October 7, 2024  
Ray Burger, Director of Planning  
Town of Dryden  
93 E. Main Street, Dryden, NY 13053

Re: Delaware River Solar  
30 Morris Road Solar Facility

I have reviewed the revised application materials provided digitally to us on September 10, 2024 along with the applicants response to comments letter also dated September 10, 2024. I have outlined additional information we recommend be provided or revised by the Applicant before commencing the environmental review.

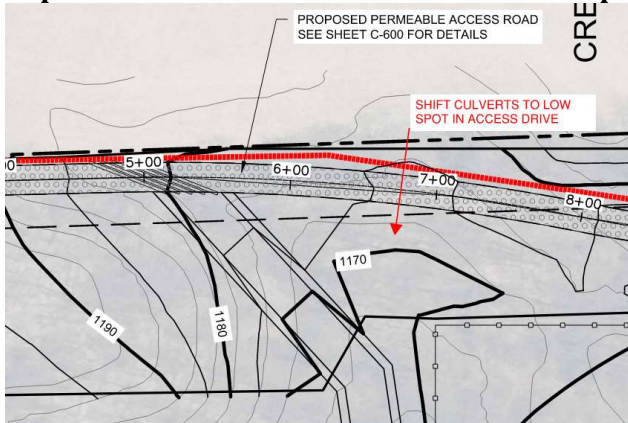
2. 6/27/24 TGM Comment: Review routing of the time of concentration between the existing conditions and proposed conditions.

7/19/24 TGM Comment: The time of concentration should be calculated from the hydraulically most distant point of a watershed. The time of concentration shown on the C-603 begins is in the middle of a much larger watershed that extends up to Morris/W Malloryville Rd. Please provide a drawing of the watershed boundaries, areas, and update time of concentration flow path and

calculations. Alternatively, review use of diversion swales or adjusting location of practices to treat impervious surfaces.

**10/7/24 TGM Comment: Provide offsite watershed delineation. Consider shifting the five culverts south to the apparent low point in the access drive. Consider routing off-site stormwater through the site similar to the existing conditions without the use of a channelized diversion swale. Offsite stormwater could be dispersed through the proposed water bars while maintain a similar flow path. Consider moving rain gardens to capture impervious surface and not route the entire project area through these practices.**

*7/11/24 PWGC Response: The time of concentration between the existing conditions and proposed conditions has been revised and is included in the Stormwater Pollution Prevention Plan (SWPPP). The routing of the TOC for the proposed conditions is based on the change in grade for the property (existing was a combination of wooded hills and grassed pastures; proposed gradual 10% slope). This TOC has been reviewed and confirmed (shown on Sheets C-603 & C-604).*

*9/10/24 PWGC Response: A grassed waterway and five (5) 24" CMP culverts have been added north of the project area in order to divert stormwater from offsite to the existing wetlands onsite and away from the proposed rain gardens, therefore the time of concentration has remained the same to focus on the disturbed areas for pre-construction and post construction flows.*
